# Product Change Notification

## 110908 - 01

**Change Notification #:** 110908 - 01  
**Change Title:** Intel® Desktop Board DP67DE, Boxed and Bulk  
PCN 110908-01, Product Material  
Replace PWM CONTROLLER  
Reason for Revision: Add CPU Socket Cover change  
**Date of Publication:** August 10, 2011

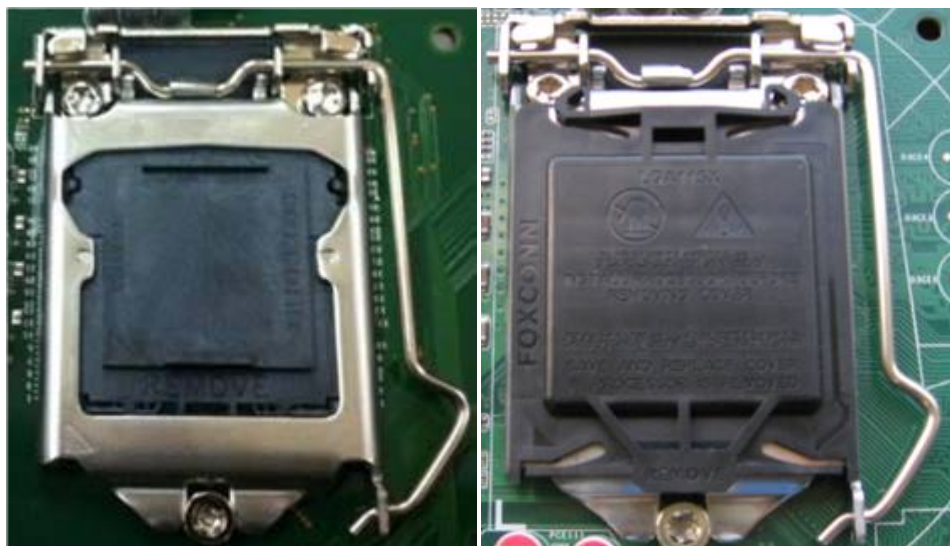
1. The Pulse Width Modulation controller CHIL 8104 upgraded from version E4 to E5 to enhance performance.
2. The CPU socket cover will be changed to the ILM version.

Current socket with PNP cover

New socket with ILM cover
